Nomad

SERVICE BULLETIN

CONTROL COLUMN COVER (MOD N557)

Figure 1 View Looking Inboard LH Control Column

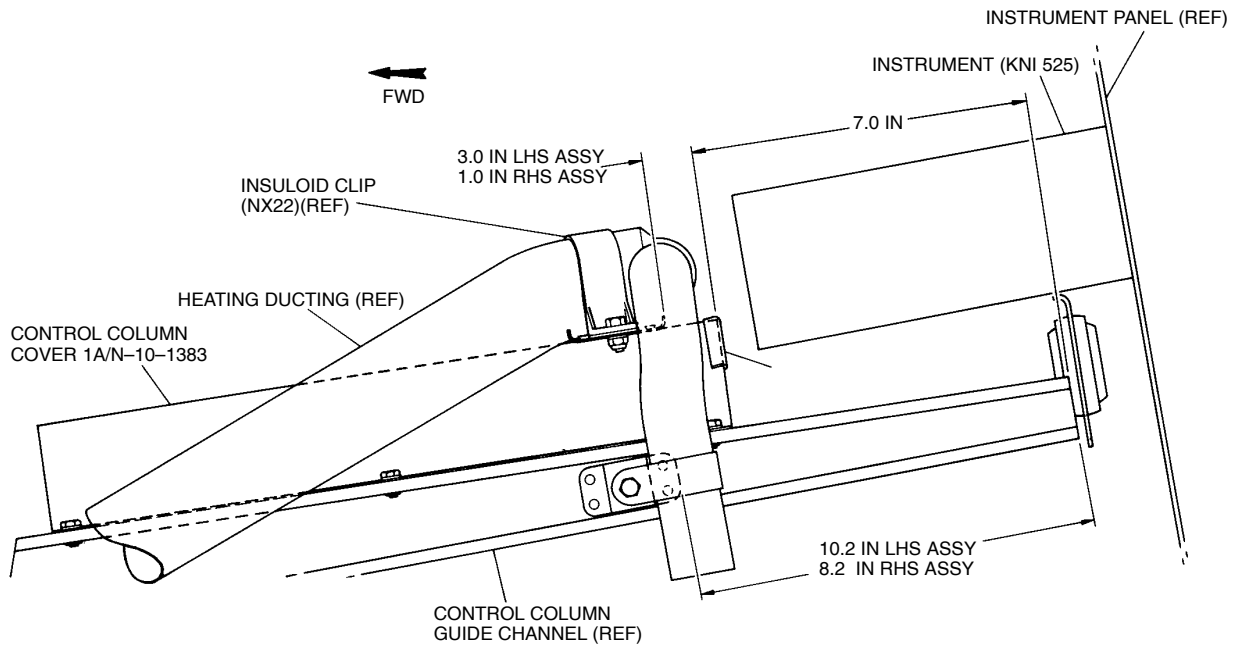
- (1) Position control column covers PN 1A/N-10-1383 over the LH and RH control column assemblies guide channels with the rear edge 7.0 inches from the end of the guide channel (Ref Figure 1).

- (3) Position the two clip mounts PN 1C/N-10-1383 in the guide channels. The rear edge of the clip mounts on the LH control column guide channels should be positioned 10.2 in from the rear end of the guide channels (Ref Figure 1).

- (5) Repeat Para 2.C.(3) and (4) on the RH control column guide channels with the exception that the rear edge of the clip mounts should be positioned 8.2 in from the rear end of the guide channels (Ref Figure 1).

Figure 2 Sectional View Looking Aft LH Control Column

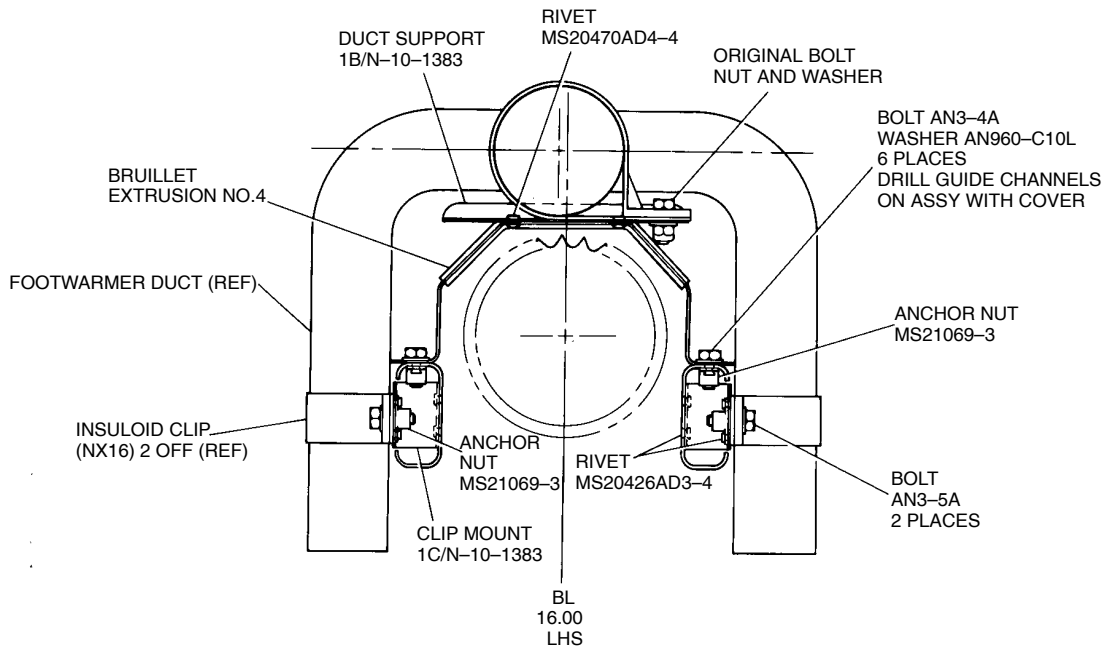
- (6) Position an anchor nut on each of the clip mounts (Ref Figure 2) and drill two off 2.45mm dia holes in each for the anchor nut retaining rivets. Countersink the retaining rivet holes to a depth of $0.036 \frac{+.003}{-.001} in$

- (11) Position a 4.4in length of Bruillet No.4 protective plastic extrusion strip centrally over the rear edge of each control column cover (Ref Figure 2).

Figure 3 Manufacturing Data for Mod N557

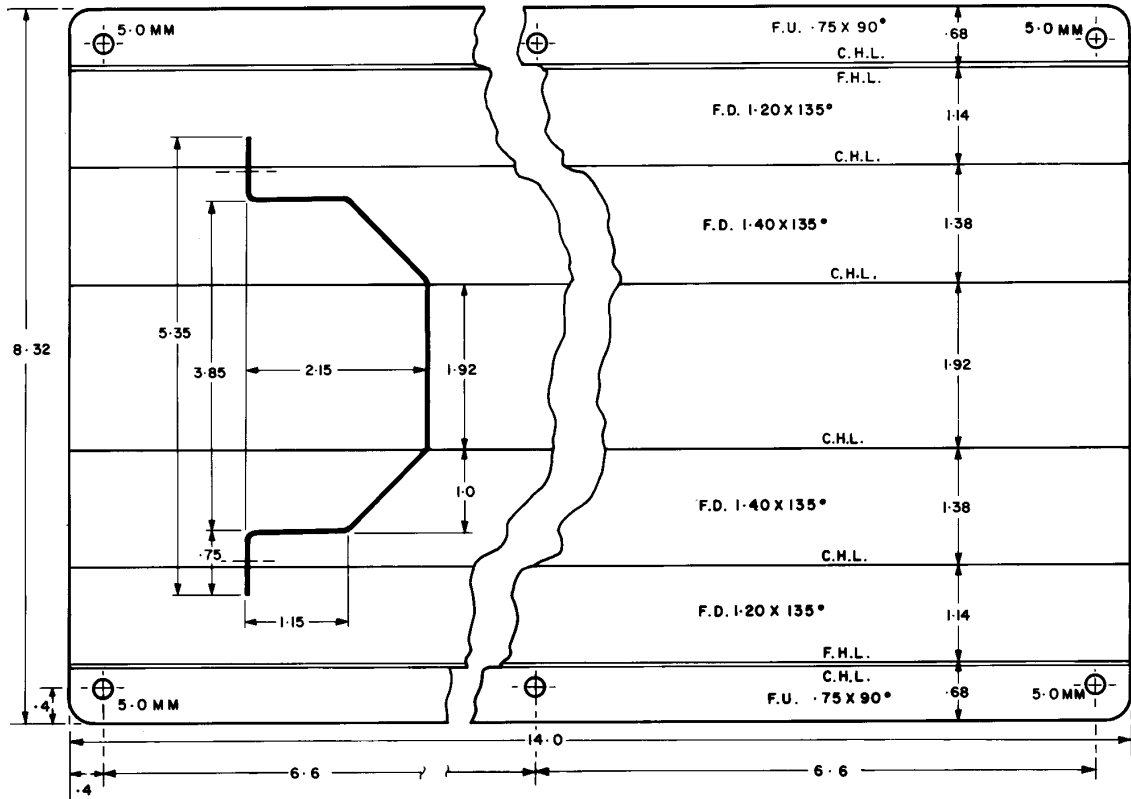
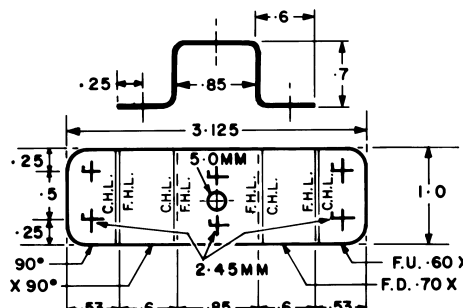
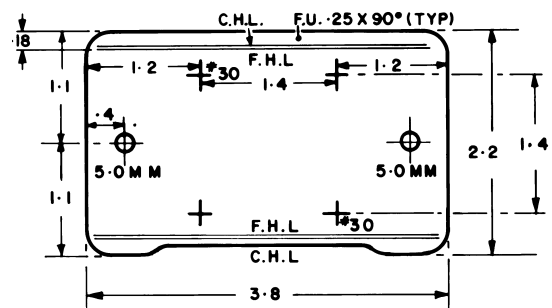
(1) Sheet metal parts are to be manufactured locally. For manufacturing data refer to Figure 3.

The parts listed in Para 3.A.(1) are to be locally manufactured in accordance with the data detailed in Figure 3.

- (1) The following parts, which are to be locally manufactured (Ref Figure 3), are required to modify each aircraft.
